# MONROE COUNTY PLAN REVIEW COMMITTEE

**Thursday, March 9, 2023  
5:30 pm**

<b>PLANNER</b>	Drew Myers
<b>CASE NUMBER</b>	REZ-23-1, Lake Lemon Marina Rezone
<b>PETITIONER</b>	Werner Group LLC c/o Stephen Werner
<b>ADDRESS</b>	9554 E Northshore DR, parcel no. 53-01-35-100-017.000-003
<b>REQUEST</b>	Rezone Request from LB to LB (w/ the request to remove the prior rezone condition of approval for a shared driveway) Waiver of Final Hearing Requested
<b>ACRES</b>	3.41 +/- acres
<b>ZONE</b>	Limited Business (LB)
<b>TOWNSHIP</b>	Benton North
<b>SECTION</b>	35
<b>PLATS</b>	Platted; Northshore Final Plat Amendment One
<b>COMP PLAN DESIGNATION</b>	<b>Rural Residential</b>

<b>CASE NUMBER</b>	PUO-23-2 and PUD-23-2
<b>PLANNER</b>	Anne Crecelius
<b>PETITIONER</b>	Monroe County Redevelopment Commission/Crider & Crider Inc. c/o Daniel Butler, Bynum Fanyo & Assoc.
<b>REQUEST</b>	North Park PUD Outline Plan Amd. #5 Change to Section 8 “Street and Alternative Transportation Guidelines Preliminary Hearing Waiver of Final Hearing Requested
<b>ADDRESS</b>	N Curry Pike and W Hunter Valley RD, Parcel #53-05-29-200-008.000-005, 53-05-19-400-021.000-004, 53-05-19-400-050.004-004, 53-05-20-300-008.000-004,

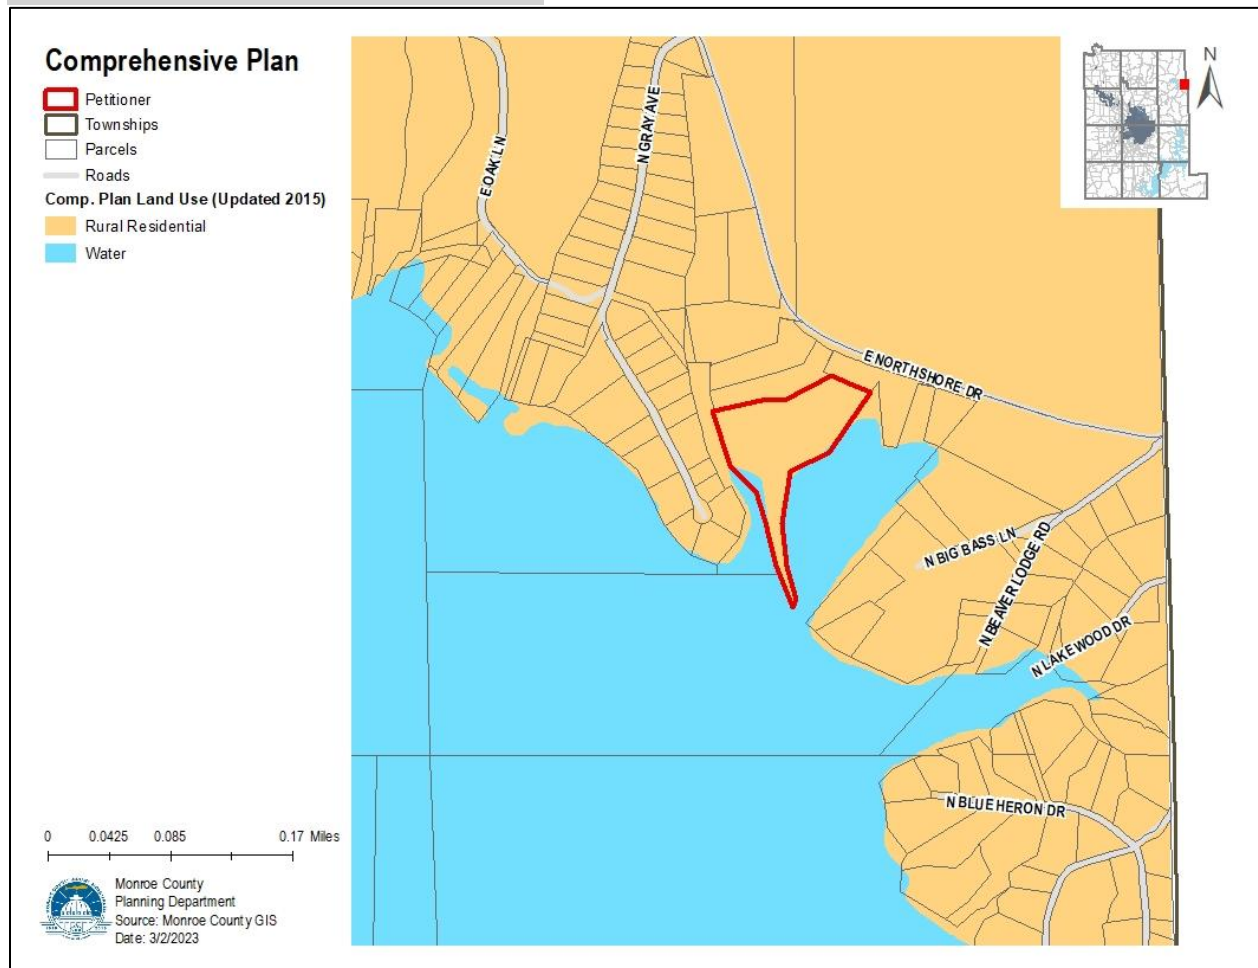
Northshore Drive is classified as a Minor Collector with an ADT of 534. Due to the hill and curve to the west the required sight distance of 335.0' and the driveway spacing requirement of 150.0' of Monroe County Code Chapter 755; 755-11 cannot be obtained. I recommend that the condition of approval of the Northshore Subdivision to share the existing driveway entrance remain.

### Removal of Road Connections: Curry Pike/Hunter Valley to Arlington

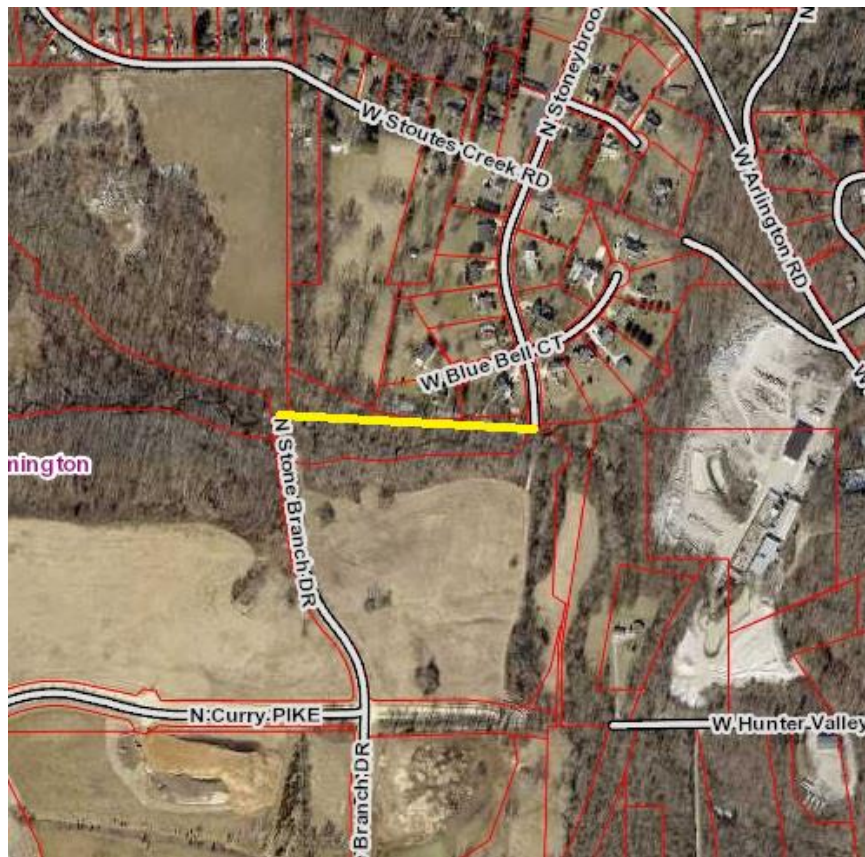
The ordinance currently requires a frontage road to be constructed that connection SR 46 to Arlington Road. See image below for approximate location (shown in yellow). This road connection would be constrained by the width of the North Park property at the proposed connection to W Arlington RD. The parcel shape is a “flagpole” like shape and doesn’t contain enough of area to construct a road to county standards.

Proposed Standard: All text referencing NP b21 will be removed.
